TELEVISION TECHNICAL BULLETIN

<u>MODELS</u>	56FW53H	66FW53H	66FW54H	76FW53H
	76FW54H	66GF63H	66GF64H	76GF63H
	76GF64H	59ESD7H	66ESD7H	28HW53H
	32HW53H

Reference SP014701X

IC 701

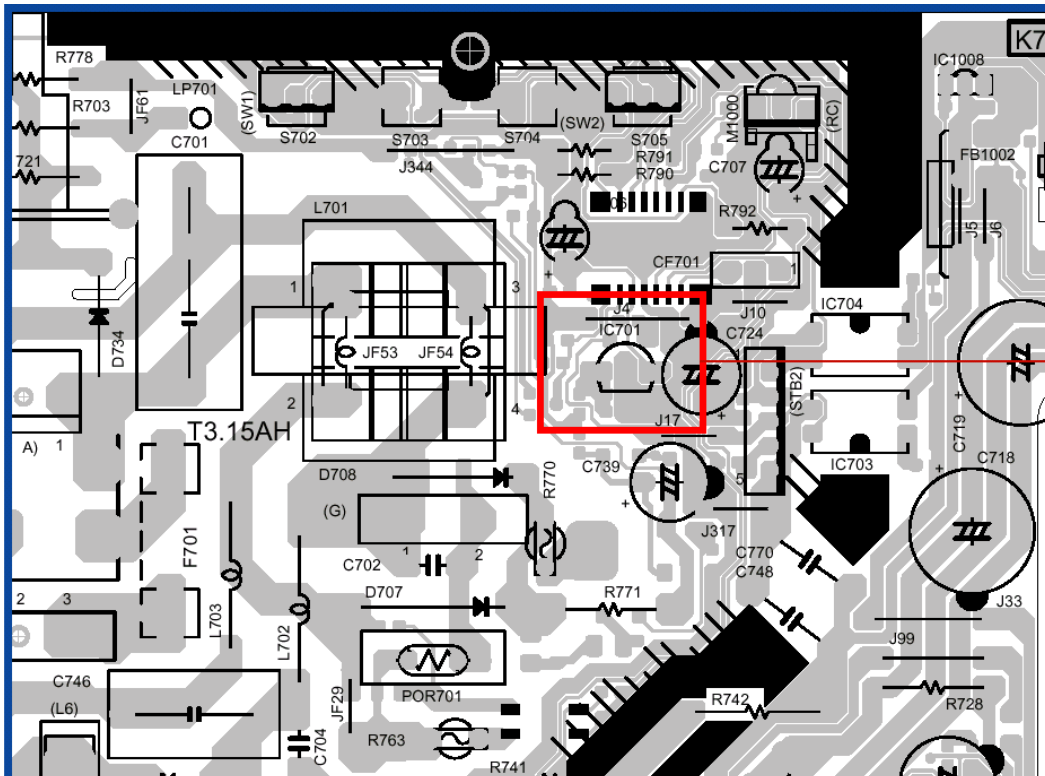
SYMPTOM Set Resets whilst being watched or Switches on from Stand-by on its own.

CAUSE Problem with Slave microprocessor ON TIMER function.

ACTION Remove the parts listed below (IC701, R708, and C728). See location parts on next page.
